# TC-WR445

## SONY SERVICE MANUAL

### SUPPLEMENT-2

Subject : 1. EXPLODED VIEWS  
(CHASSIS SECTION)  
2. CHANGE OF SYSTEM CONTROL,  
PANEL (C), HEADPHONE,  
POWER TRANSFORMER,  
PANEL (A) AND PANEL (B)  
BOARDS

6-1. CHASSIS SECTION

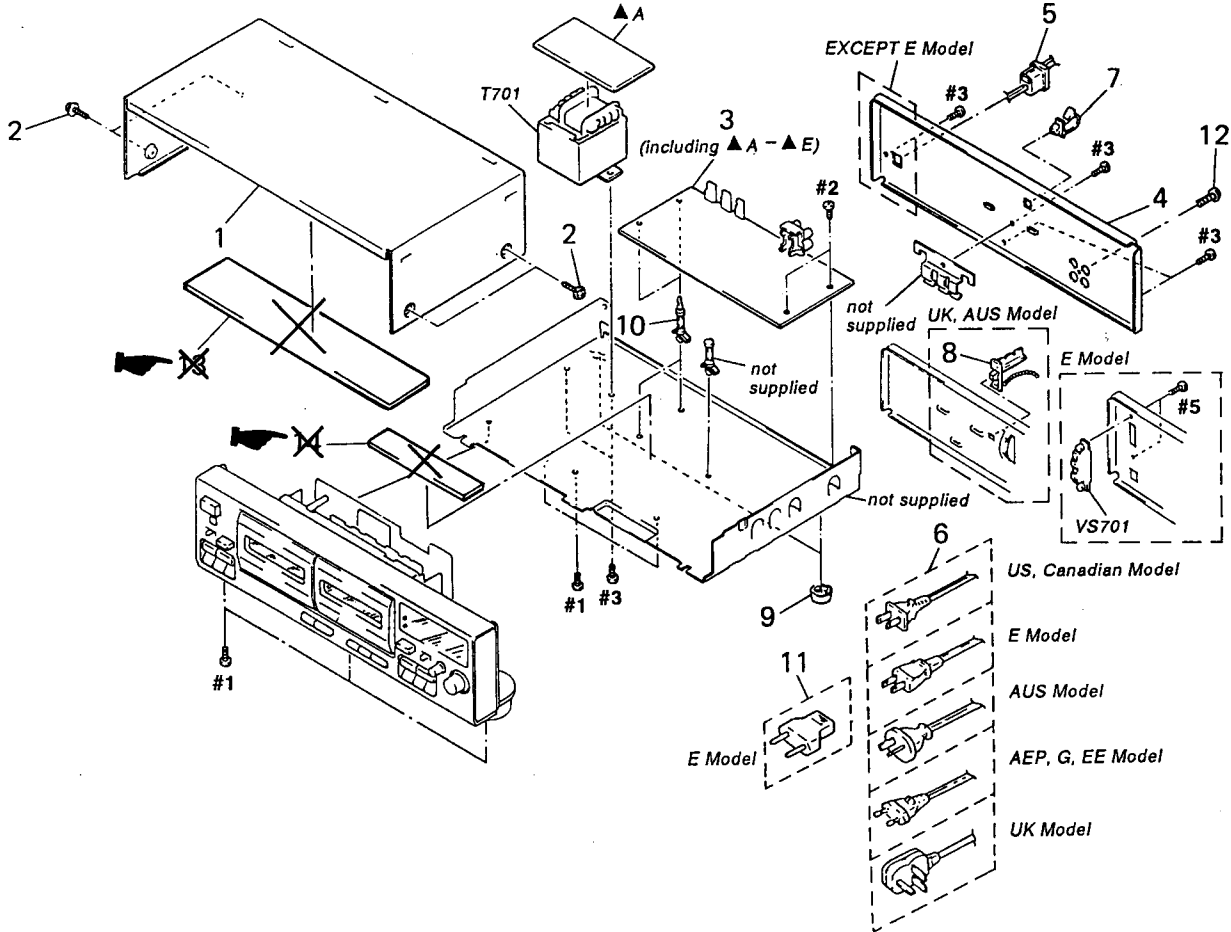
: Indicates changed portion

Former Type			New Type		
Ref. No.	Part No.	Description	Part No.	Description	Remark
13	3-917-191-01	ABSORBENT (A), VIBRATION			Deleted
14	3-917-192-01	ABSORBENT (B), VIBRATION			Deleted
